RE: BAIADA INTEGRATED POULTRY PROCESSING FACILITY (SSD 9394) – SUPPLEMENTARY RESPONSE TO SUBMISSIONS

We are writing with respect to SSD 9394 for the Integrated Poultry Processing Plant at 1154 Gunnedah Road, Westdale. As you are aware, since the initial response to submissions was submitted on 3 July 2020, the Applicant has received additional submissions from various agencies and departments via DPIE. These matters have been raised and addressed in separate responses.

As requested, this correspondence has been prepared to provide a consolidate all the supplementary responses to submission and an updated set of development plans within a single document.

DRAWING TITLE B-DOUBLE SWEEP PATH (LIVE BIRD TRUCK ROUTE)
CLIENT BAIADA (TAMWORTH) PTY LIMITED
PROJECT OAKBURN PROCESSING PLANT
LOCATION 1154 GUNNEDAH ROAD, WESTDALE

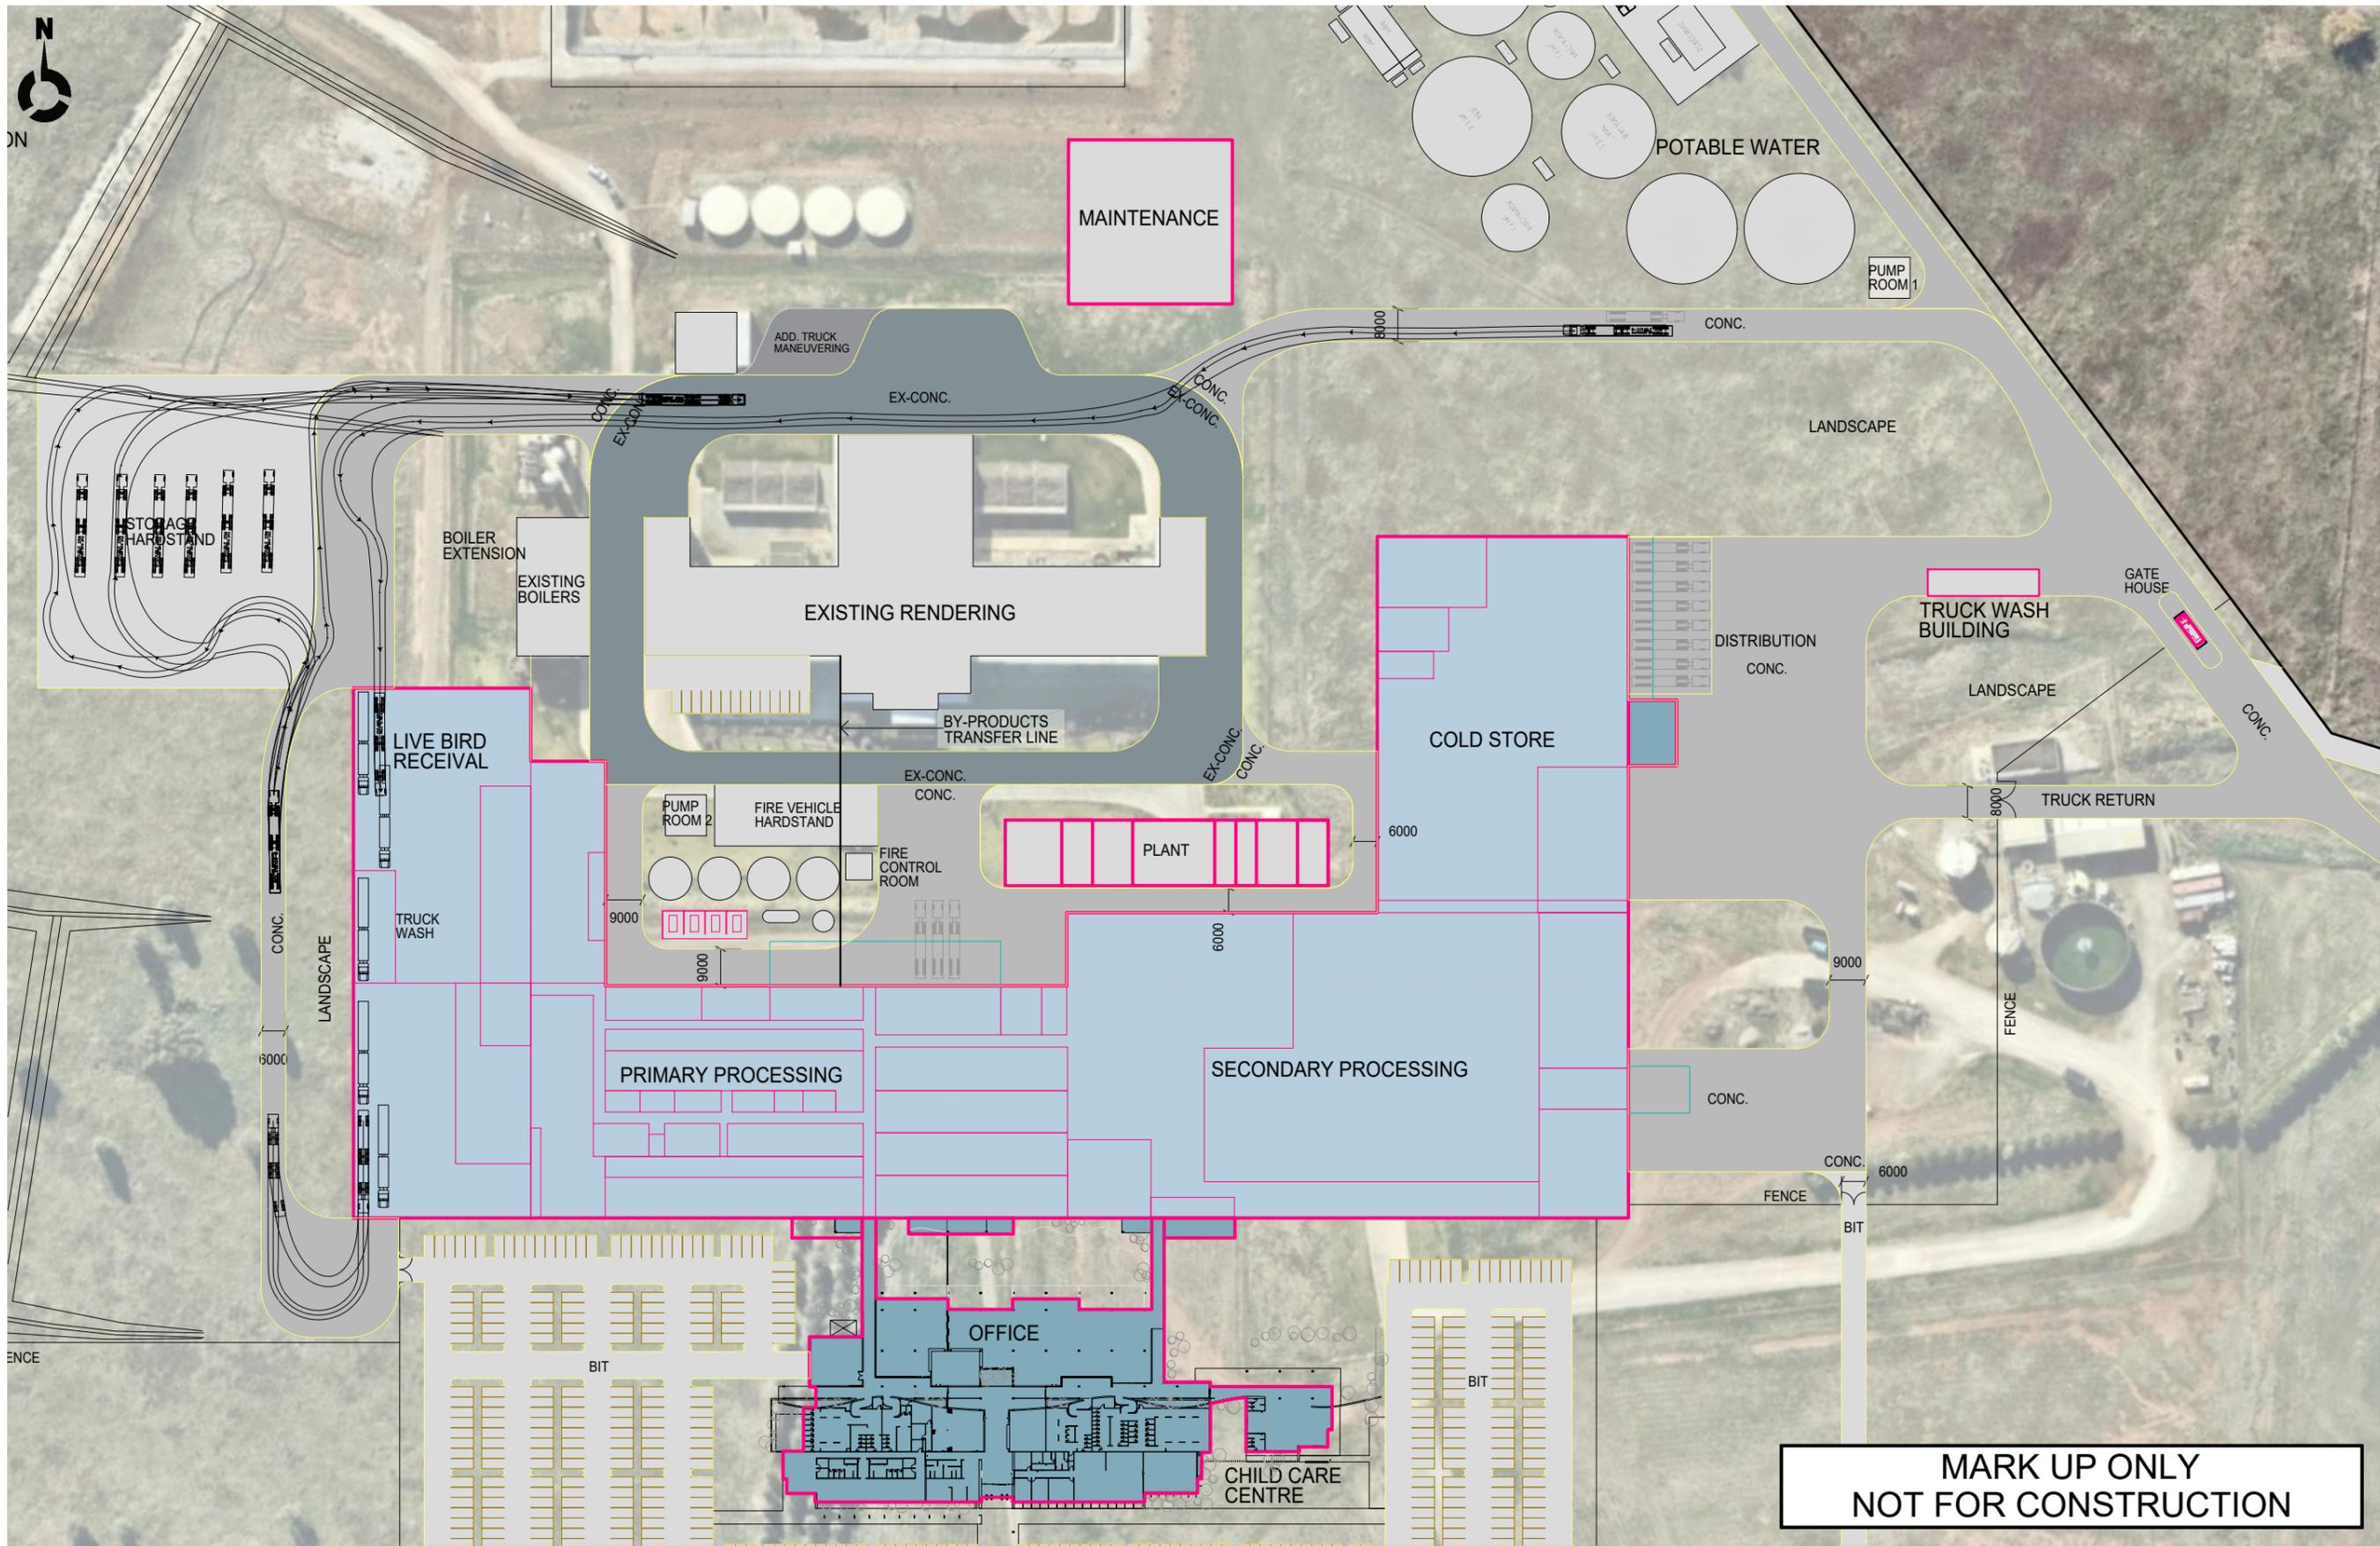
MATTERS RAISED	APPLICANT'S RESPONSE
<p><i>1. We are generally satisfied that matters raised in our correspondence dated 23 August 2019 have been addressed and will form the basis of the decision and aid in formulating conditions of any approval granted. Notwithstanding that, there are still a few matters that should be further considered and clarified during the assessment process and we ask that the Consent Authority be satisfied that they have been addressed. They are as follows:</i></p>	<p>Noted.</p>
<ul style="list-style-type: none"> <i>The new access road, which will connect to Armstrong Street should be constructed and provide the same or greater access for heavy vehicles (25/26m B-Double at HML), noting the objective of the Heavy Vehicle Access Policy Framework.</i> 	<p>The new access road connecting to Armstrong Street will be constructed to accommodate 25/26m B-Doubles. This can be conditioned accordingly.</p>
